Village of Arlington Heights
Plan Commission
Board Room, 3rd Floor
Arlington Heights Village Hall, 33 S. Arlington Heights Rd.
February 14, 2024
7:30 PM

VILLAGE OF ARLINGTON HEIGHTS
STAFF DEVELOPMENT
COMMITTEE REPORT

Project Number: PC 21-007
Project Title: 1821 N. Verde Subdivision
Address: 1821 N. Verde Ave.
PIN: 08-16-202-009, 08-16-202-010

PLAN COMMISSION PC #21-007
1821 N Verde Resubdivision
1821 N Verde Ave
Round 1

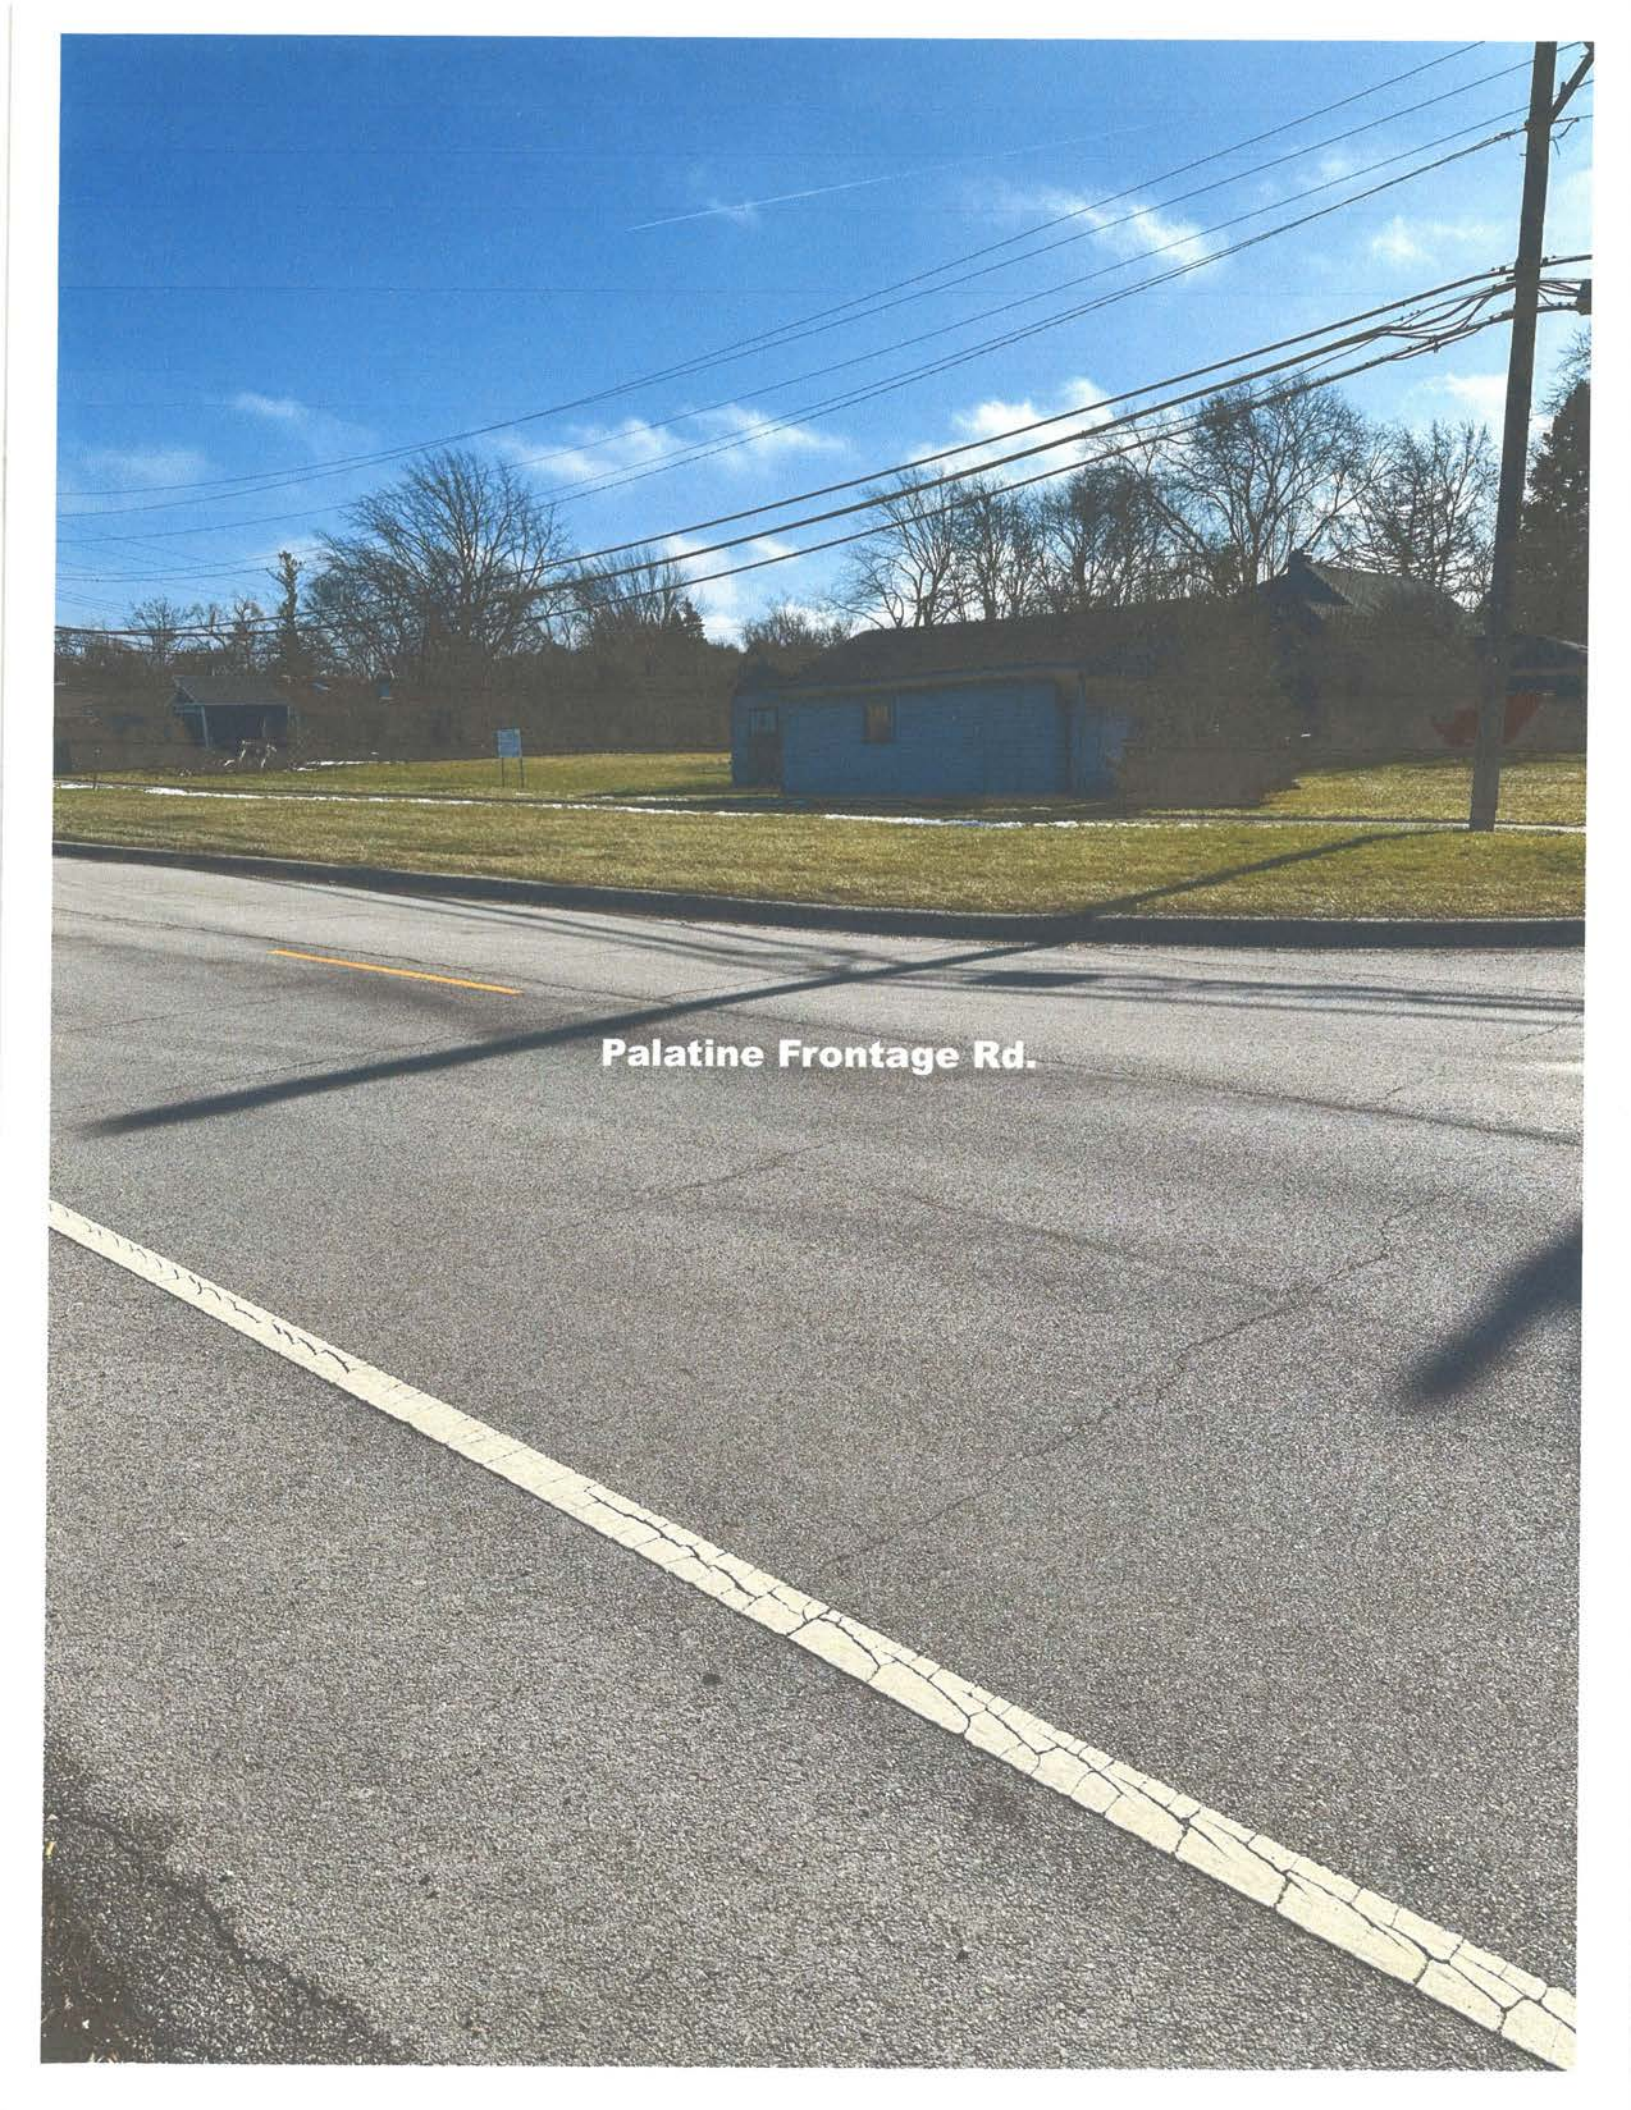
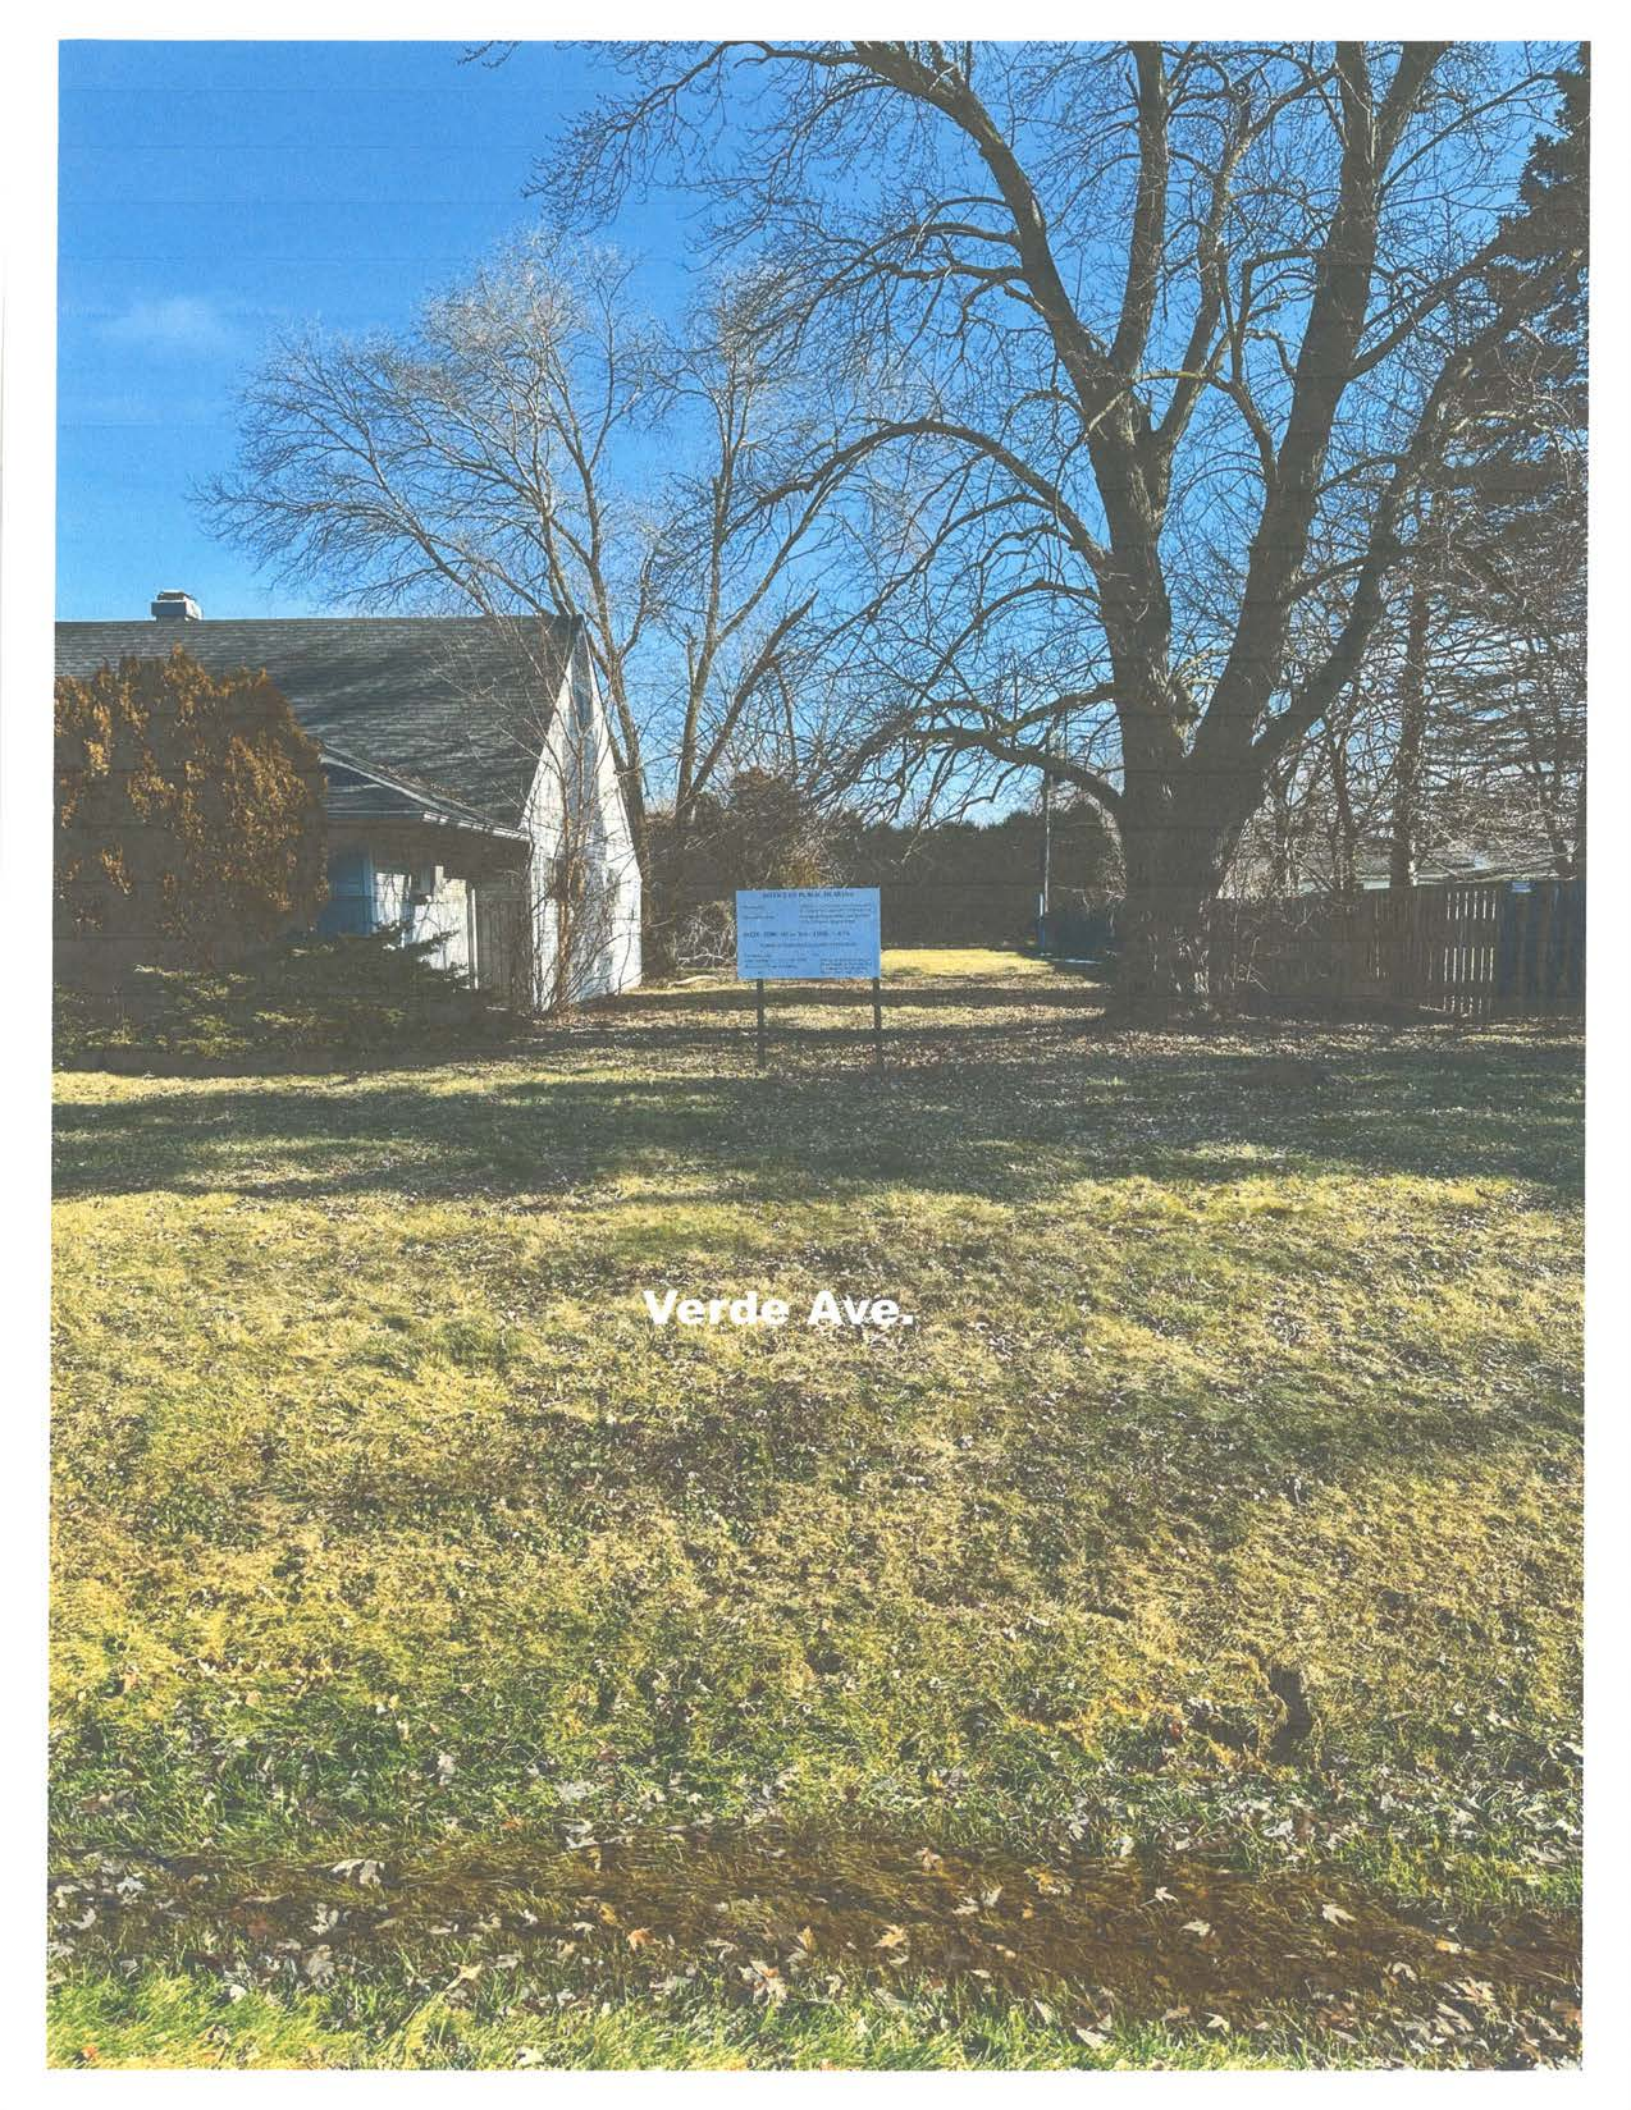
- 19. Verify and document the condition of the edge of the roadways on N Verde Ave.
 - The roadway edge of N. Verde Ave. is in very good condition. Photos labeled “Exhibit A” have been included.

- 20. Verify and document the condition of the sidewalk on Palatine Frontage Road.
 - The sidewalk on Palatine Frontage Rd. is in excellent condition and includes accessibility ramps at Verde Ave. Photos labeled “Exhibit B” have been included.
